Board of Zoning Adjustment Staff Report

November 16, 2015

Case No:	15Variance1076
Project Name:	The Mower Shop (New Building)
Location:	1142 Minor Lane
Owner(s):	Brian Humbert, JNO, LLC
Applicant:	Owner
Representative:	Kathy Matheny, Cardinal Planning and Design
Project Area/Size:	0.23 acres
Jurisdiction:	Louisville Metro
Council District:	13 – Vicki Aubrey Welch
Case Manager:	Sherie' Long, Landscape Architect

Attachment 4: Elevations

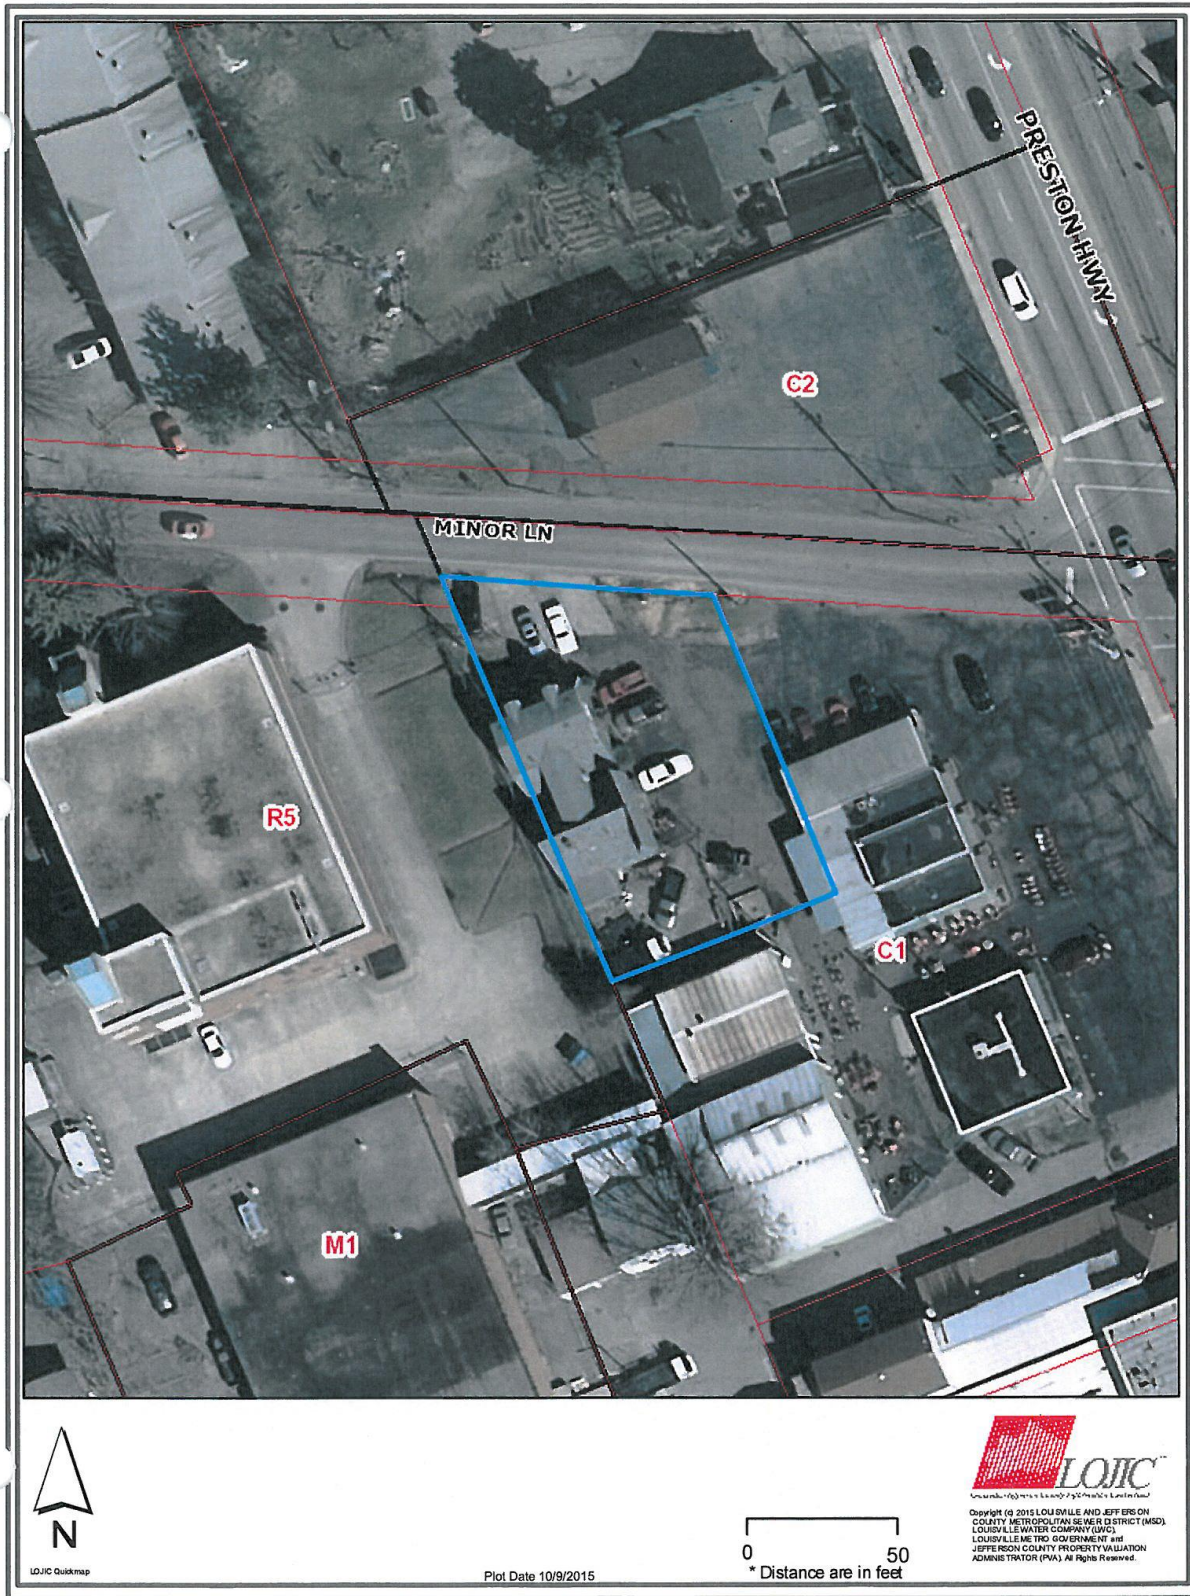
STAFF: The waiver will adversely affect adjacent property owners since the building will not have the visual interest or the human scale the existing building possesses. This building has little connection to

the surroundings. The existing building being removed has better features and is more engaging than the new proposed building.

STAFF: Guideline 3, policy 1 and 2 calls for the compatibility of all new development and redevelopment with the scale and site design of nearby existing development and with the pattern of development within the form district. The type of building materials may be considered as a mitigation measure and may also be considered in circumstances specified in the Land Development Code. When assessing compatibility, it is appropriate to consider the choice of building materials in the following circumstances: (1) projects involving residential infill (2) projects involving non-residential uses; and (3) when specified in the Land Development Code. The proposal is for a non-residential use. The Land Development Code provides building design standards for non-residential and mixed use buildings. The purpose of the regulation is to provide visual interest and a human scale that are representative of the form district through the use of windows, columns, pilasters, piers, variation of material, entrances, storefront windows, and other animating features along no less than 60% of the façade length and 50% clear glass and doors. The applicant has not provided any animating features along the street façade. The applicant has mentioned adding evergreen shrubbery along a portion of the front façade. However, considering there are no animated features being provided, the waiver request does violate the comprehensive plan.

STAFF: The extent of waiver of the regulation is not the minimum necessary to afford relief to the applicant since the applicant can provide the required animating features on the façade.

STAFF: The applicant has not incorporated other design measures that exceed the minimums of the district to compensate for non-compliance with the requirements to be waived. The strict application of the provisions of the regulation would not deprive the applicant of the reasonable use of the land or create an unnecessary hardship on the applicant since animated features could be provided along the façade.

Waiver #2 (front facade animation and clear glass and doors) appears to not be justified. The applicant is not providing any animation along this façade with the exception of an evergreen planting. The applicant could provide some animating features along this façade. Plus considering the existing building has more presents than the proposed building the applicant should be providing animating features.
